Review of the Union Electric Company Integrated Resource Plan

The Office of the Public Counsel

Technical Report

Case No. EO-2011-0271

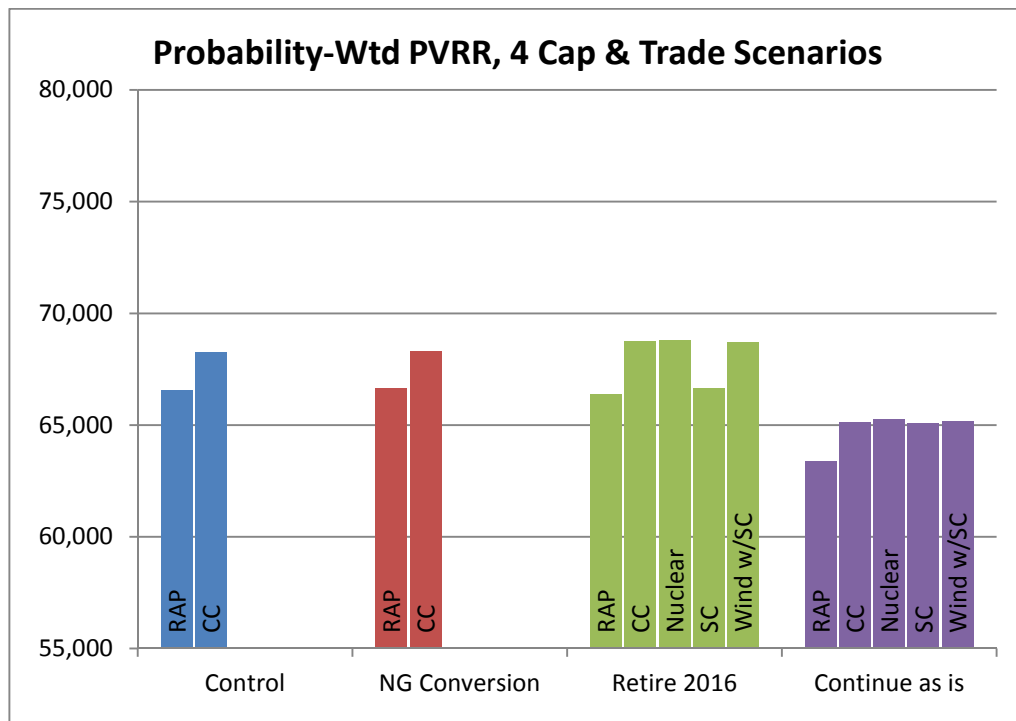
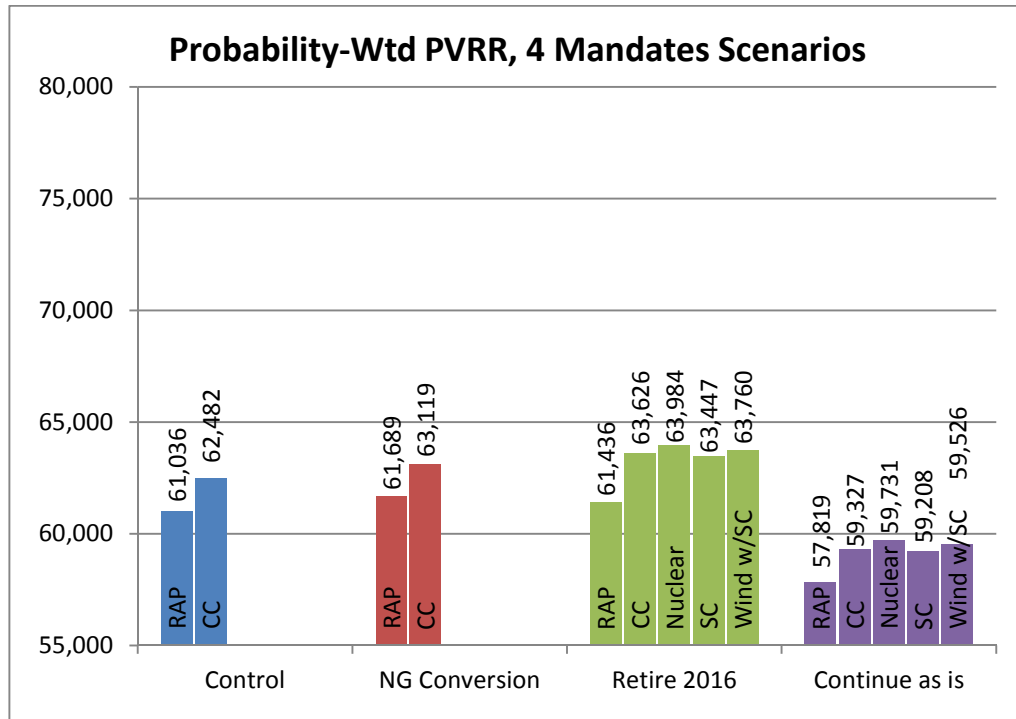
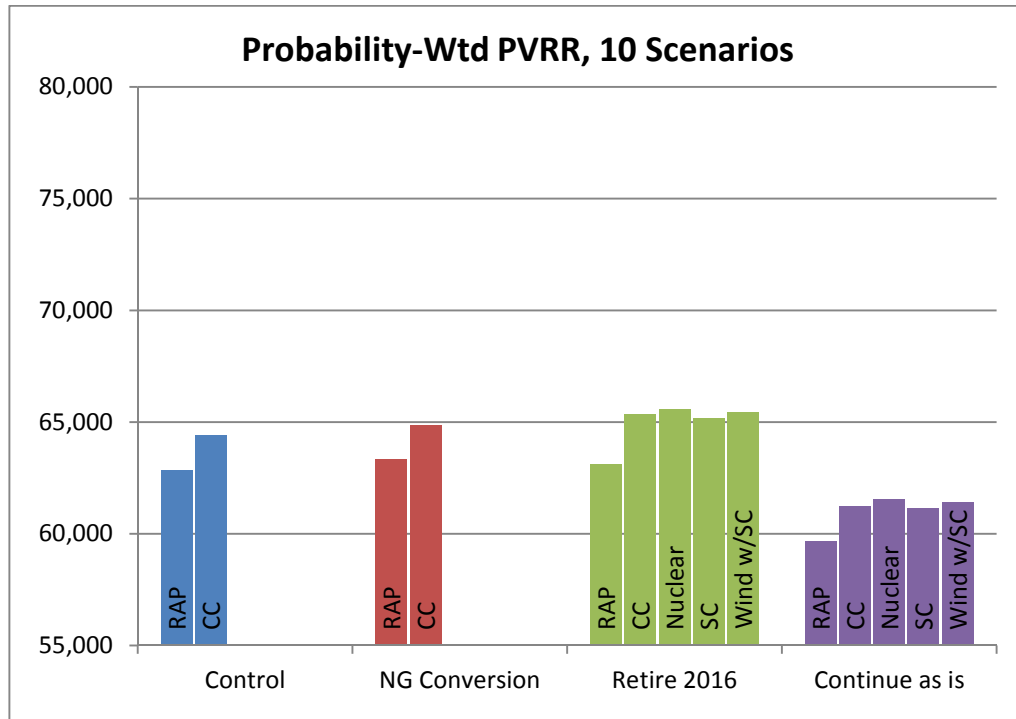
One of the most striking results of the risk analysis at this point is the finding that the plans containing the RAP level of energy efficiency clearly result in the lowest PVRR under all scenarios and sensitivities. First, UE conducts some comparisons of the RAP scenario with the Capacity Calibrated Portfolio (CCP) scenario, which combines energy efficiency and demand response at just enough amounts to defer future capacity additions. The CCP scenario includes less energy savings than the RAP scenario but greater amounts of demand response than is included in some plans with the RAP level of energy efficiency. Under all sensitivities run by the Company (including Meramec controlled, Meramec converted and Meramec retired in 2016), the RAP plans result in lower PVRR than the CCP plans.²⁰ Based on these findings, the Company decides that further analysis of plans with CCP is unnecessary.²¹

Second, UE conducts several risk analysis sensitivities of the 14 candidate resource plans. Every sensitivity conducted demonstrates that the RAP efficiency plans result in the lowest PVRR. In the cap-and-trade scenarios, RAP has lower cost than combined cycle (CC), nuclear, simple cycle (SC), and wind, whether Meramec is controlled, converted to natural gas, retired in 2016, or allowed to continue as-is. Under the environmental mandate scenarios, the same is true: RAP performs best. When all ten scenarios are probability weighted, RAP again turns out to be cheapest.

This point is demonstrated in the charts below. These charts were derived by simply rearranging the data presented in Figures 9.16, 9.17, and 9.18 in Chapter 9. The PVRR results for the RAP plans were placed directly next to the PVRR results for comparable Meramec scenarios, to provide an indication of how much money the RAP plan can save relative other plans in a directly comparable scenario. As indicated in the charts, the RAP plans result in the lowest PVRR under all of the risk analyses.
